# NORTH CHARLESTON SEWER DISTRICT

RFP TITLE: Turkey Creek Pump Station Upgrade

### ADDENDUM NUMBER 2 – April 28, 2025 – 03 PAGES

D102	FILE NO.		CADD NO.	SCALE:	1"

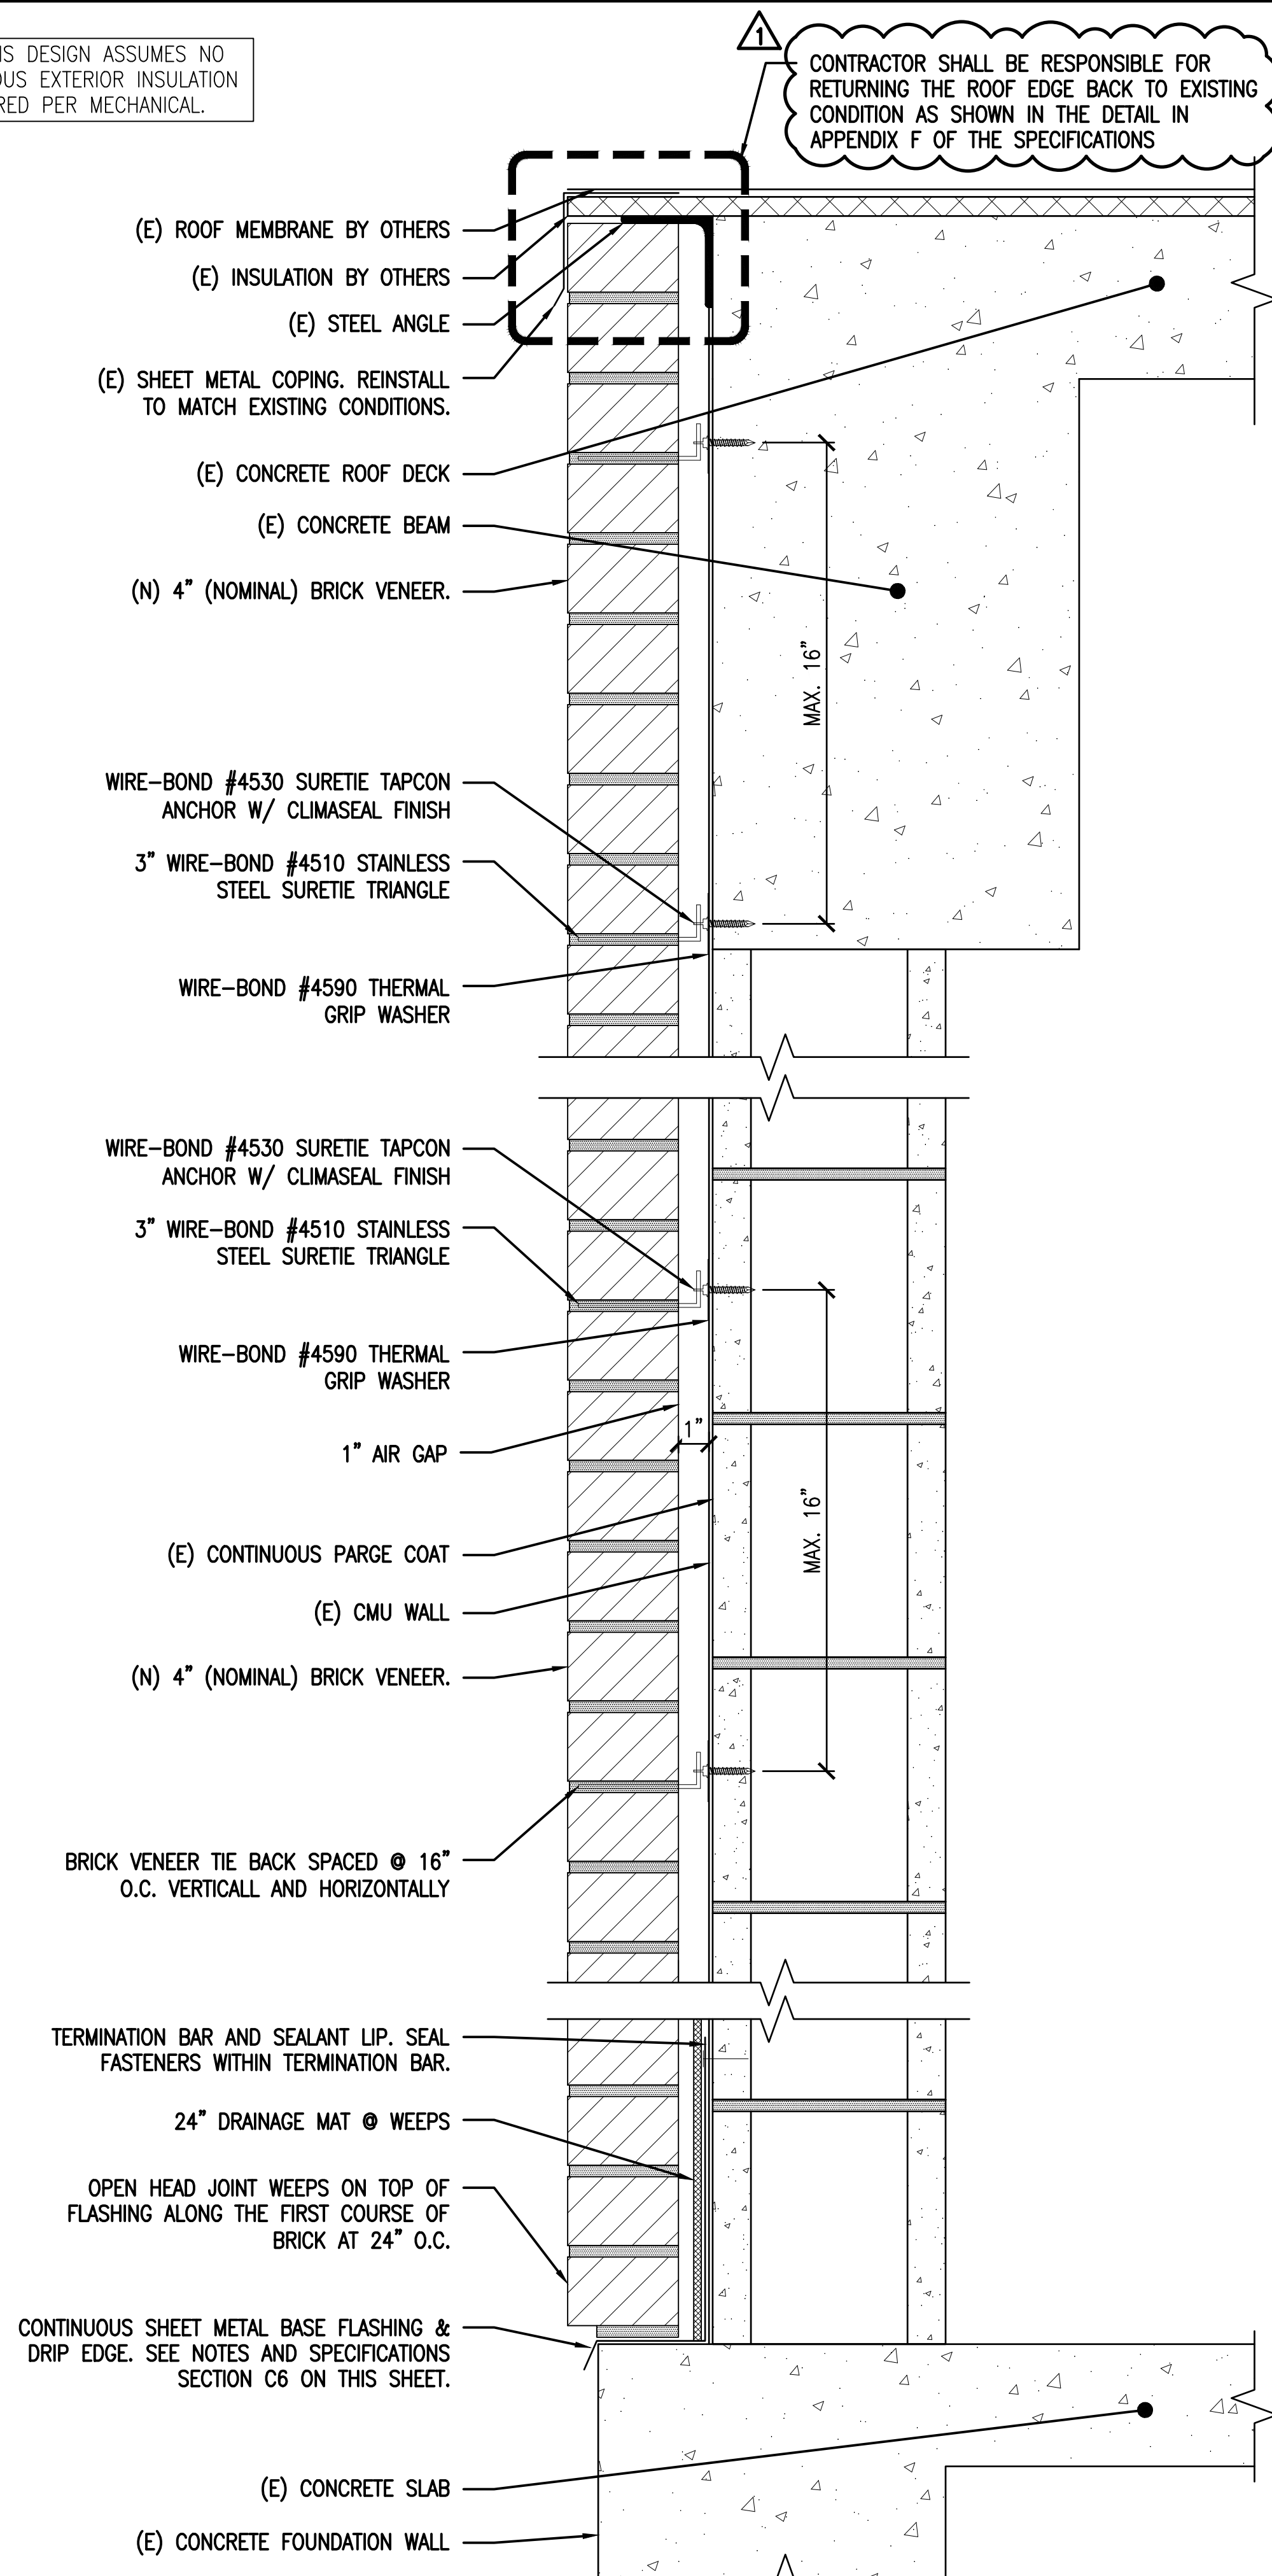
3. Regarding the temporary bypass, the spec displays that one standby pump system of each size be maintained onsite. Does that mean N+1?
  - As far as redundancy for the bypass pumping configuration. We only want to require that they have/there is redundancy built in so that if any one of the pumps in their configuration (primary or secondary) goes down, that they still have one backup pump that would afford them the ability to handle the bypass flows as required by the plans
4. Bar Screens: The notes indicate to replace the Bar Screens with Stainless Steel Bar Screens in each channel. However, the drawing shows only one section being replaced in each channel.

Question: Are we replacing all the screens in the channels, or just one on each side?

- Only one section of screens is being replaced in each channel, and is appropriately marked on the plans.
5. Exterior Paint: The note on the drawings that addresses exterior paint states to paint all vertical concrete surfaces & exposed piping. However, the schedule of values indicates to paint all paintable non-brick surfaces.
